REACTOR VESSEL OVERPRESSURIZATION  
DISTRIBUTION PER G. ZECH 10-21-76

Info concerning implementation option re installation of acceptable long-term improvements to mitigate overpressurization transients.....

Donald C. Cook Nuclear Plant Unit No. 1  
Docket No. 50-315  
DPR No. 58

This letter is in response to Mr. Dennis L. Ziemann's letter dated January 10, 1977 which requested that we identify the implementation option we have selected for the installation of acceptable long-term improvements to mitigate overpressurization transients. There were also staff positions and requests for additional information listed in enclosure 1 to Mr. Ziemann's letter. Our responses to the staff positions and requests for information are provided in Attachment 1.

FIGURE 2

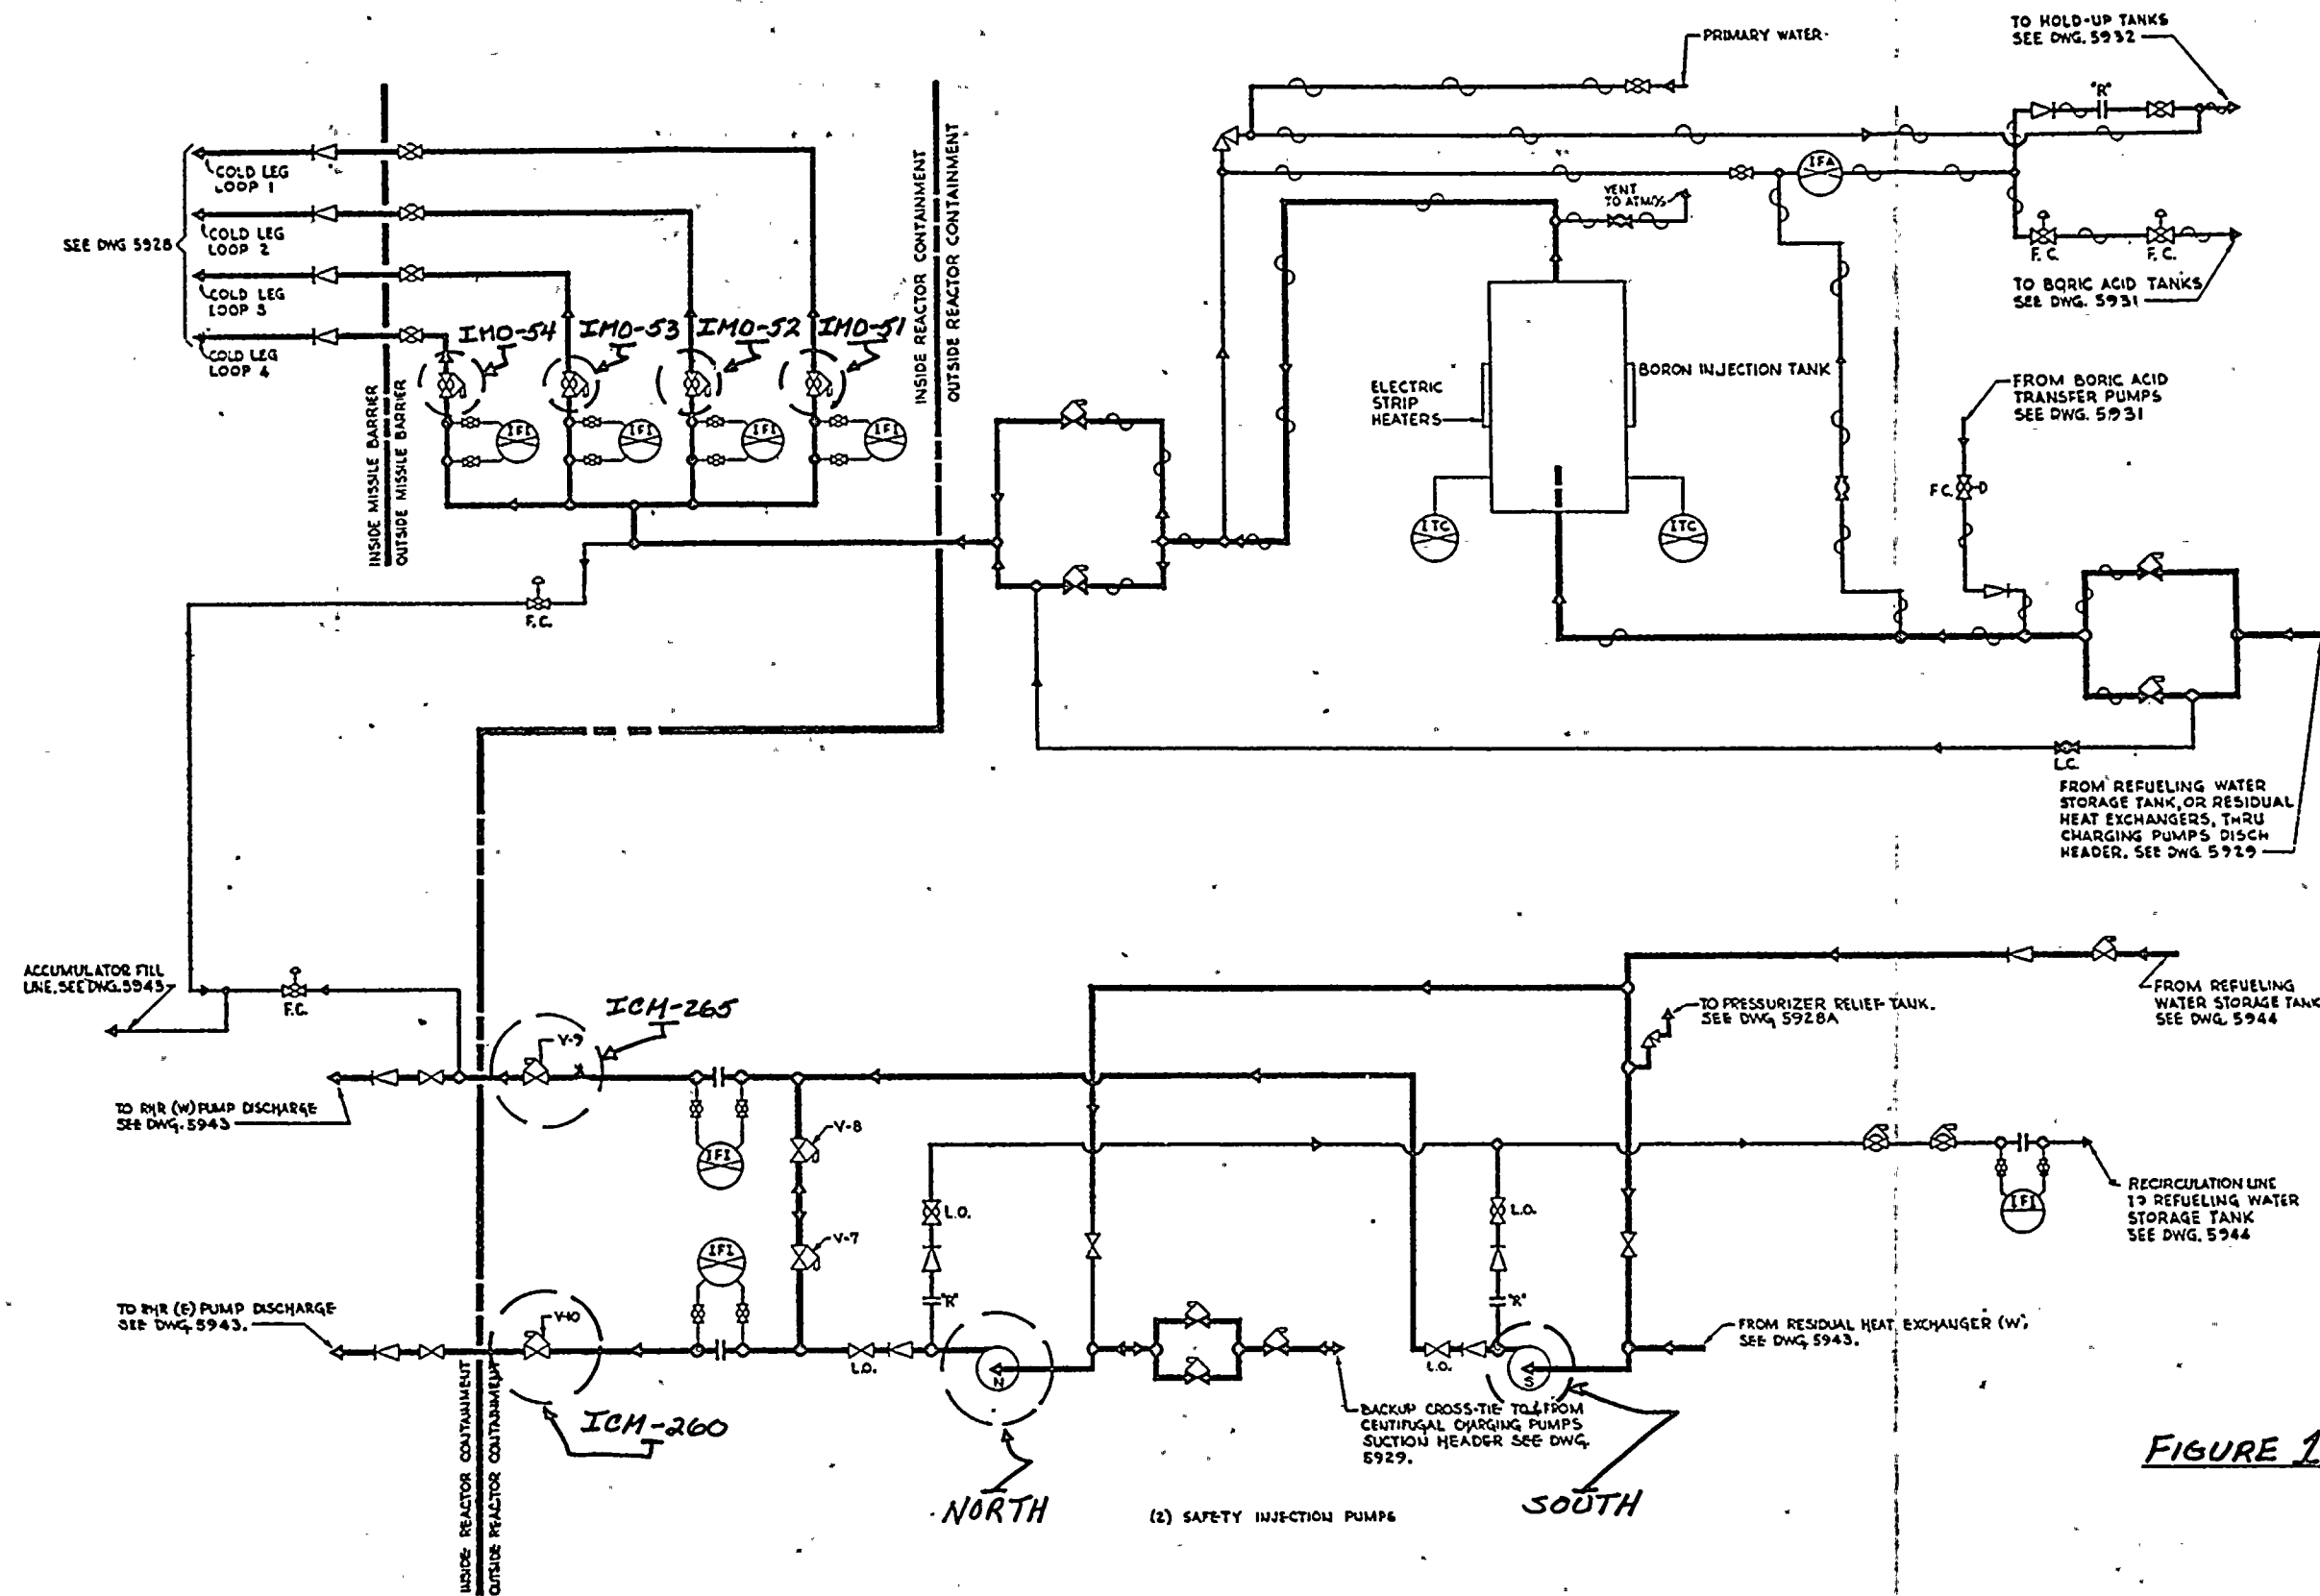
- a) RHR Design pressure is 600 psig.
- b) Figure 2 identifies the RHR isolation valves relevant to overpressure incidents by means of two hexagons. The valves are Copes-Volcan, double disk, motor operated gate valves.
- c) RHR - Interlocks, setpoints, alarms:  
RHR pump suction valves: IMO-128 and ICM-129.
  - 1. IMO-128 is interlocked with RCS wide range pressure channel NPS-122. When pressure drops below 425 psi, a permissive signal allows the operator to manually open this valve. If the pressure increases above 600 psi, this valve is closed automatically.

FIGURE 1

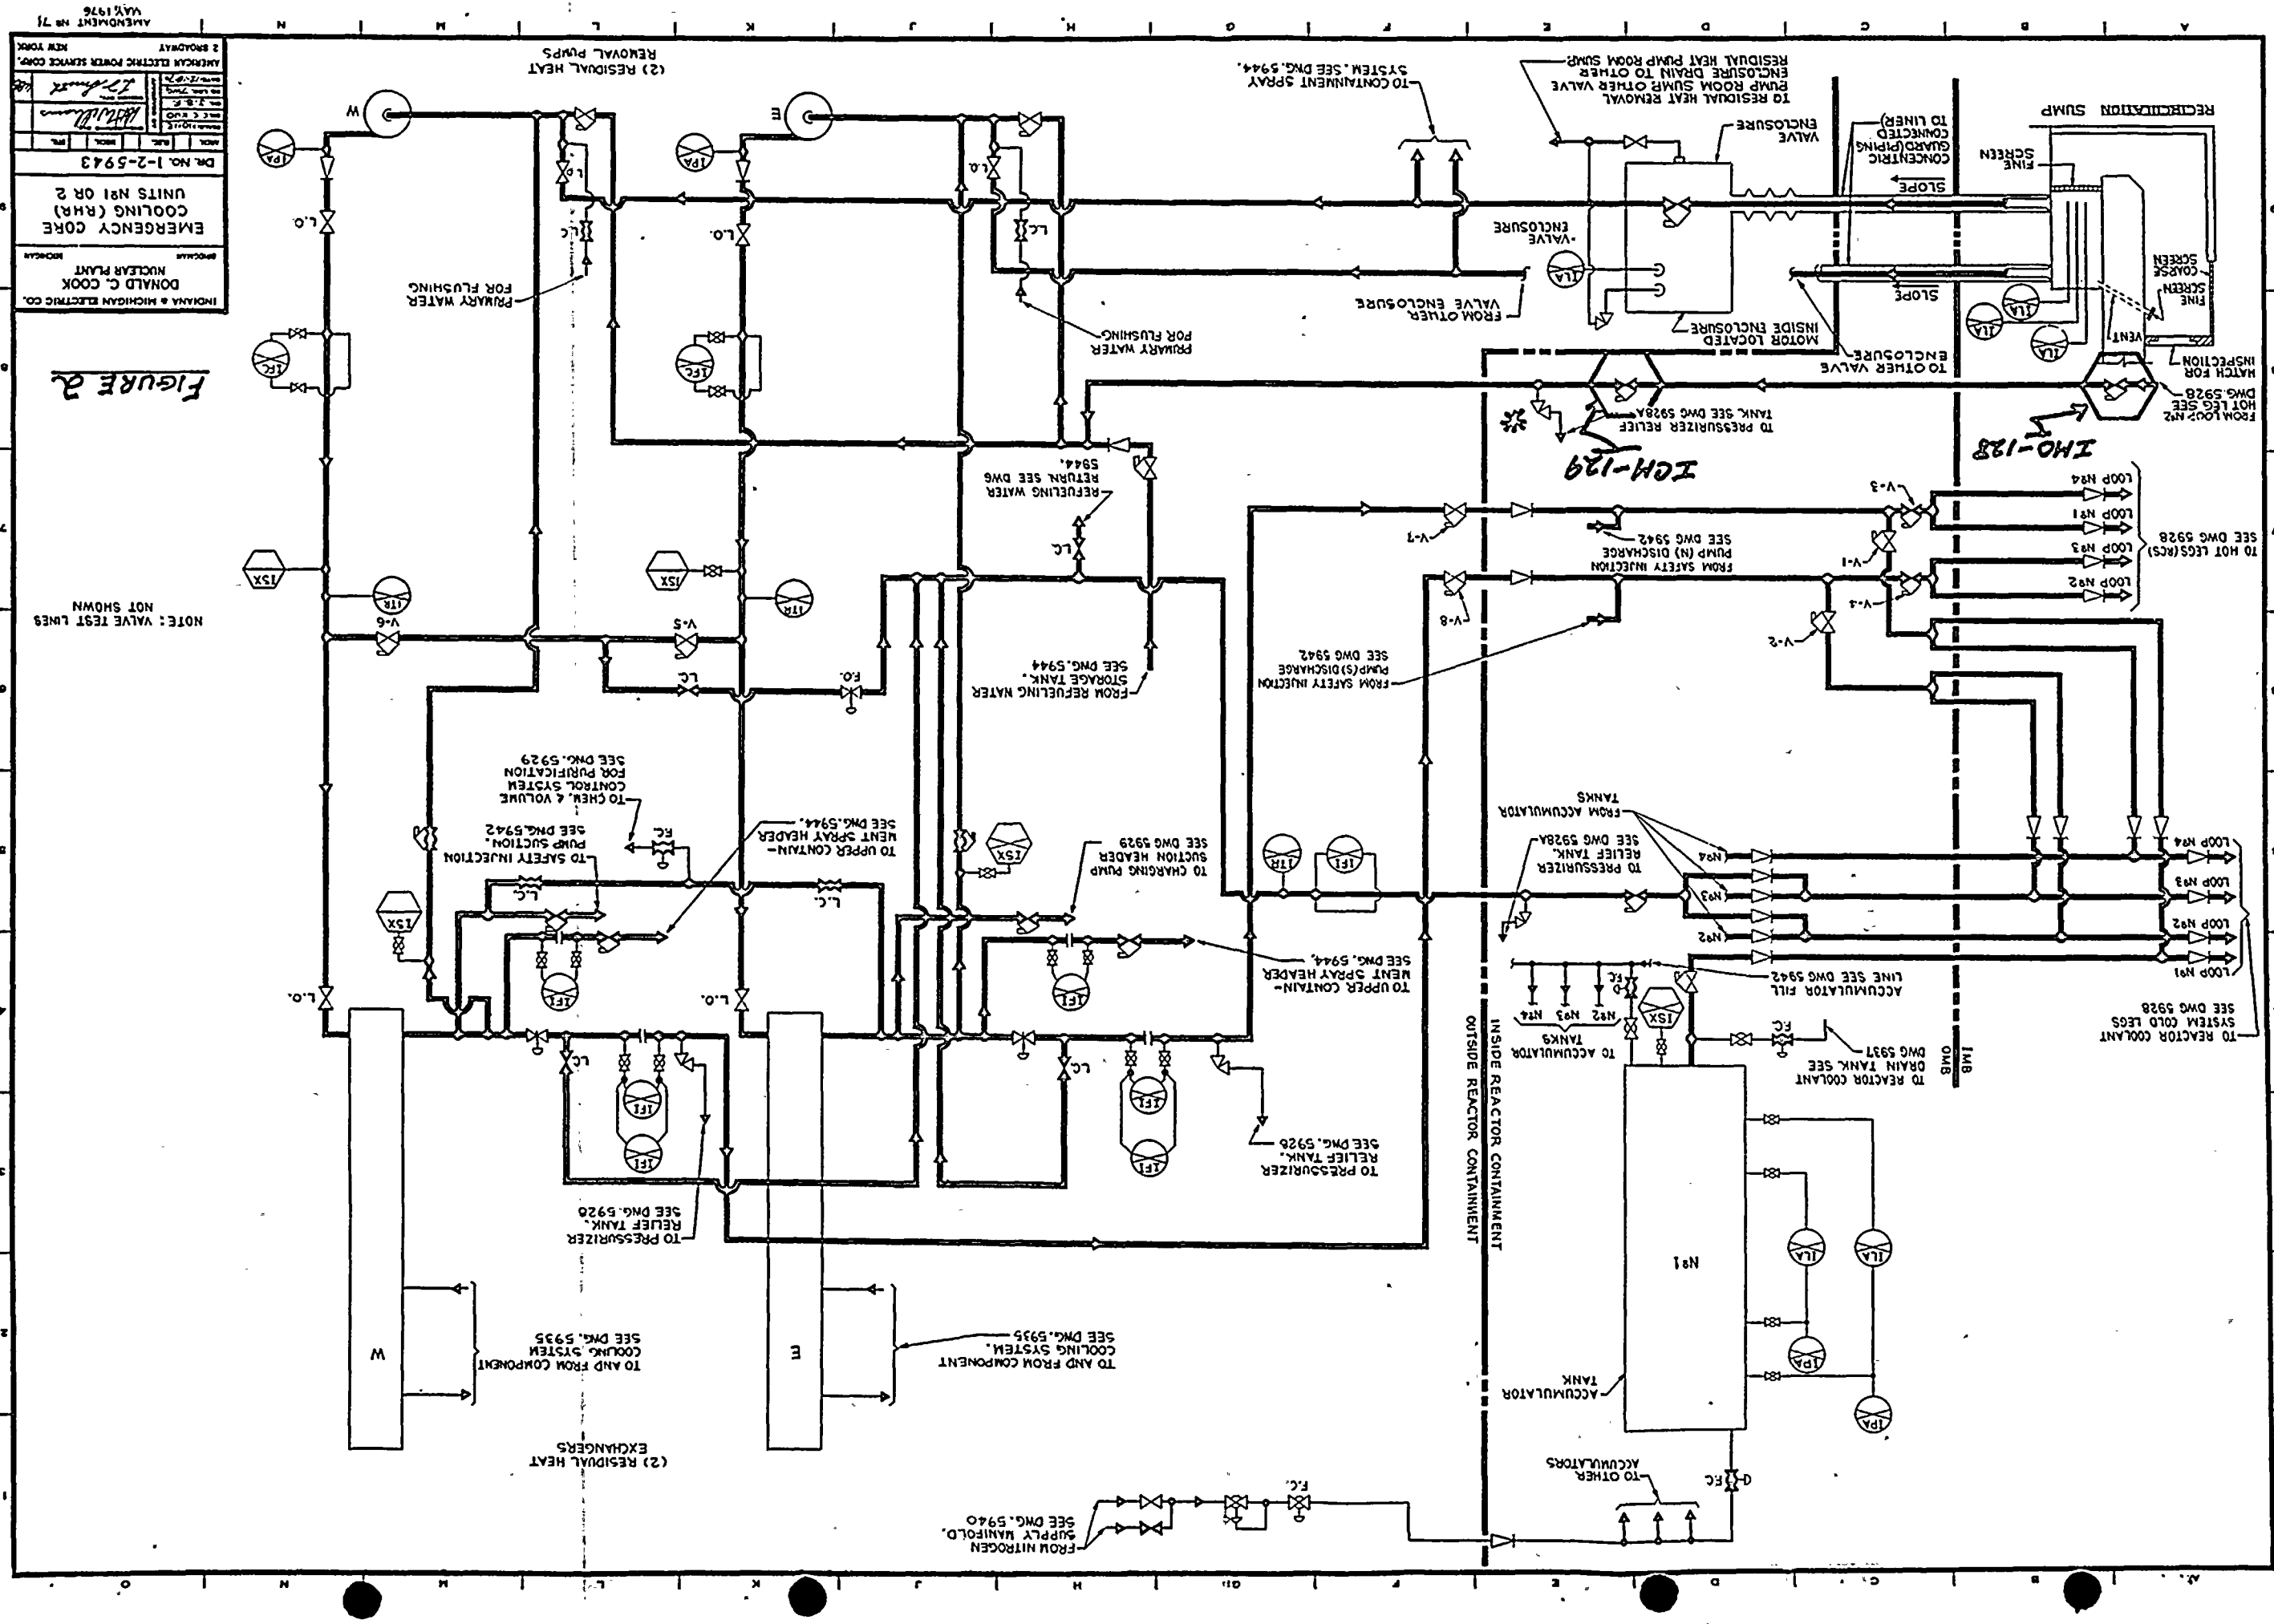
- a) Figures 1 and 2 (attached) show the SIS flow paths into the RCS.
- b) Figures 3 and 4 show the head-flow characteristics of both (North & South) SIS Pumps.
- c) The valves and pumps to be closed and de-energized are shown on Figure 1 by being circled with a dotted line. Items are identified as North and South ("N" and "S") pumps, valves V-9 (ICM-265) & V-10 (ICM-260) and valves IMO-51, IMO-52, IMO-53, IMO-54.
- d) The present revision of the plant cooldown procedure requires the accumulator valves to be closed and the breakers for each to be racked out and tagged. The SIS pumps are also de-energized and the supply breakers racked out and tagged.

A temporary sheet has added the following valves to the cooldown procedure:

Cold leg injection valves IMO-51, 52, 53, and 54

SI pump discharge valves ICM-265 and 260 (V-9 & V-10 respectively)

The change requires these valves to be closed and the breakers for each racked out and tagged.

SUBJECT RCS OVERPRESSURE ALARM - RFC-DC-12-1332

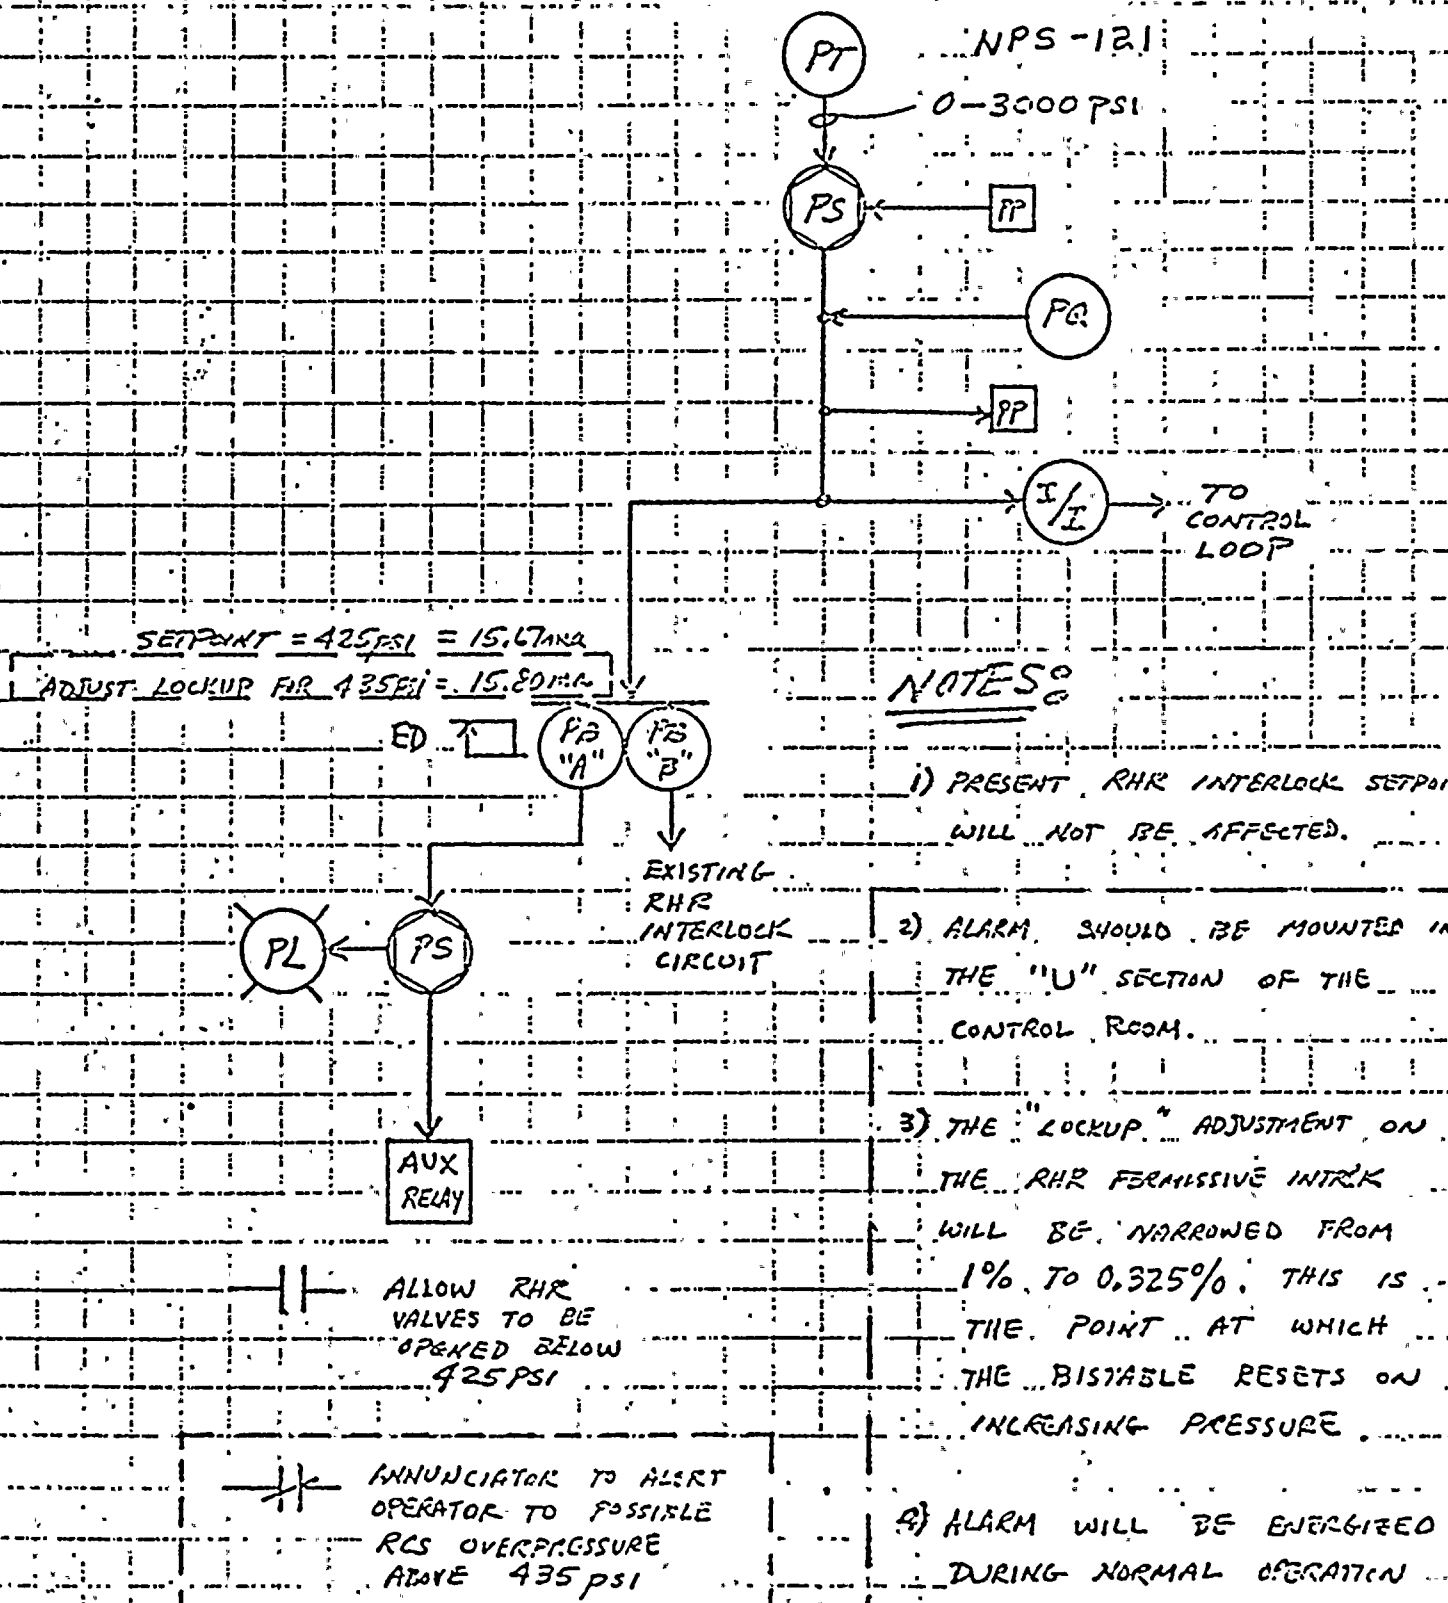
- a) The "operator alert" alarm was installed prior to the December 23, 1976 refueling outage.
- b) The system modifications are shown in Figure 5 (attached).
- c) The alarm setpoint, mode of annunciation and sensor are shown in Figure 5.
- d) It is not anticipated that the Cook Nuclear Plant will be operated in a water-solid condition.
